DART AEROSPACE LTD		Work Order:	164426
Description: Tube		Part Number:	D3016-3
Inspection Dwg: D3016	Rev: A		Page 1 of 1

DESIGN <i>CP</i>	DRAWN BY <i>CP</i>	DART AEROSPACE LTD HAWKESBURY, ONTARIO, CANADA	
CHECKED <i>#</i>	APPROVED <i>#</i>	DRAWING NO. D3016	REV. A SHEET 1 OF 3
DATE 01.05.18		TITLE SEAT FRAME ASSEMBLY	SCALE NTS
A	01.05.18	NEW ISSUE

DRAWING NO. D3016	TITLE SEAT FRAME ASSEMBLY	REV. A	DART AEROSPACE LTD ENGINEERING ORDER	D.E.O. NO. D3016-A-1	SHEET NO. SHEET 1 OF 1	SCALE NTS
DRAWN <i>1</i>	CHECKED <i>UP</i>	MFG. APPR. <i>RE</i>	APPROVED <i>MP</i>	DE APPR. <i>TH</i>		
DATE 10.01.29	DATE 10.01.29	DATE 10.01.29	DATE 10.01.29	DATE 10.01.29

TO REVISE D3016-11 SADDLE'S HOLE SIZES

D3016-11 SADDLE

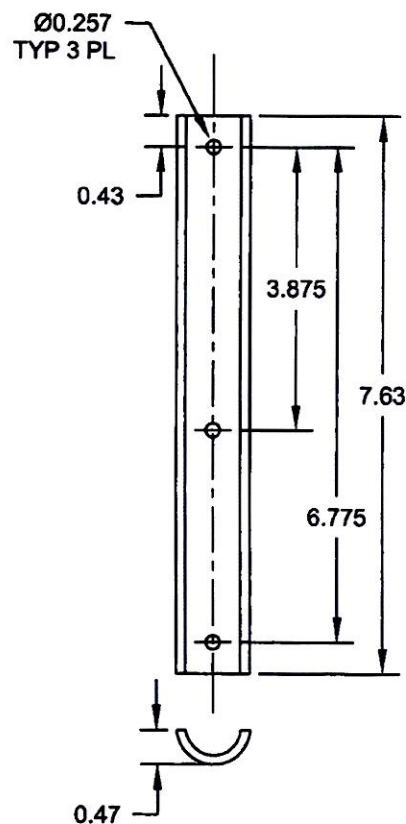
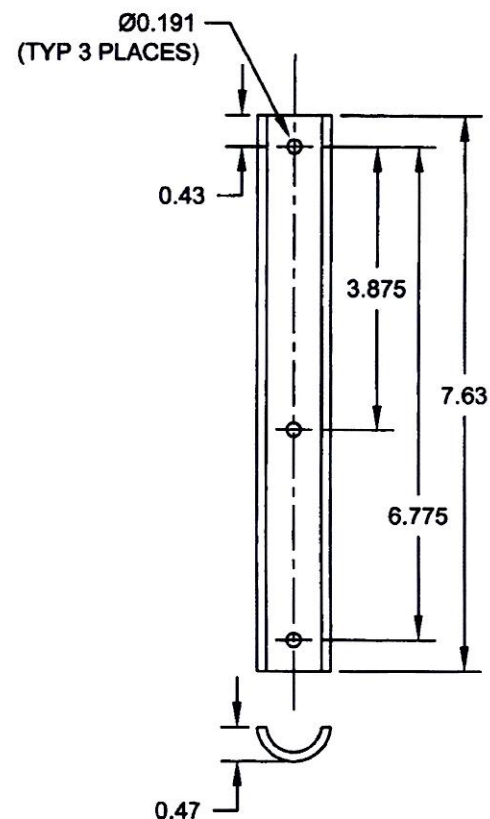
DETAIL D3016-11 SADDLE (SHEET 3): Ø0.257 TYP 3 PL WAS Ø0.191 (TYP 3 PLACES) AS SHOWN:
